# Access Compliance Report

## Public Rights-of-Way

Intersection ID: 13568	Main Street: ARLINGTON_AV	Cross Street: SOUTH_BV	Location: SE
ADA ID: 3B88711A0844	Ramp Type: PerpDiag	Initial Pass/Fail: Fail	Overall Compliance: No
Codes/Mitigation Info/Possible Solution		Field Measurements/Component Compliance	
Severity Score: 21.25

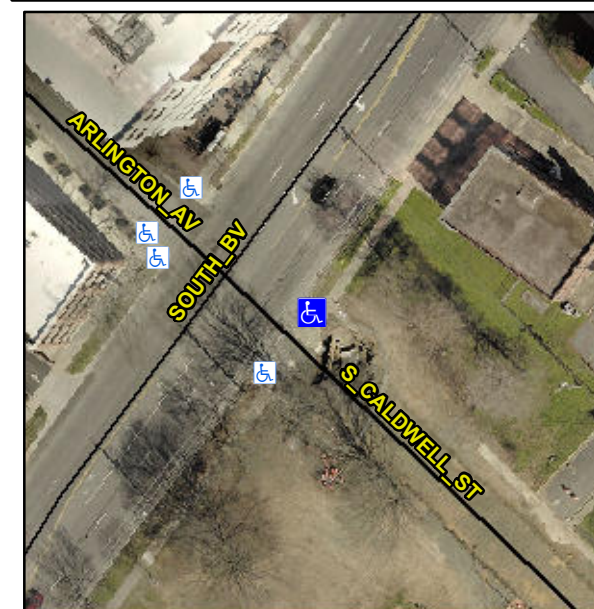
Compliance	Description	Data	Compliance	Description	Data
N/A	Ramp Length (in)	60.0	Yes	Ramp Slope (%)	6.6
No	Ramp Width (in)	42.0	No	Ramp XSlope (%)	5.4
N/A	Flare Type LT	N/A	N/A	Flare Type RT	N/A
N/A	Flare Slope LT (%)	N/A	N/A	Flare Slope RT (%)	N/A
N/A	Flare Traversable LT?	N/A	N/A	Flare Traversable RT?	N/A
N/A	Landing Length (in)	N/A	N/A	DWS Provided?	N/A
N/A	Landing Width (in)	N/A	N/A	DWS Contrast?	N/A
N/A	Landing Slope (%)	N/A	N/A	DWS Length (in)	N/A
N/A	Landing X Slope (%)	N/A	N/A	DWS Full Width?	N/A
N/A	Landing Curb? (Y/N)	N/A	N/A	DWS Offset (in)	N/A
N/A	Shared Landing?	N/A			
N/A	Gutter Ponding?	N/A	N/A	Gutter Slope (%)	N/A
N/A	Gutter Lip Ht (in)	1.0	N/A	Gutter X Slope (%)	N/A
N/A	Painted X Walk1?	No	N/A	Painted X Walk2?	Yes
	X Walk 1 Direction	To NW		X Walk 2 Direction	To SW
N/A	X Walk 1 Width (in)	N/A	N/A	X Walk 2 Width (in)	118.0
	X Walk 1 Slope (%)	3.8		X Walk 2 Slope (%)	1.4
	X Walk 1 X Slope (%)	3.1		X Walk 2 X Slope (%)	6.8

N/A	Ramp inside XWalk1?	N/A	N/A	Ramp inside XWalk2?	Yes
	Road Slope (%)	3.9	N/A	Clear Space?	N/A
	Road X Slope (%)	3.5	N/A	Clear Space to XWalk (in)	N/A
N/A	Any Obstructions?	N/A	N/A	Storm Grate/Utility Hazard?	N/A
	Obstruction Type			Storm Grate/Utility Type	
		N/A			N/A
			Yes	Surface Condition? (G/P)	Good

**Remove & Replace Curb Ramp With Two New Directional Ramps or Equivalent.**

**R304.5.1, R304.5.3**
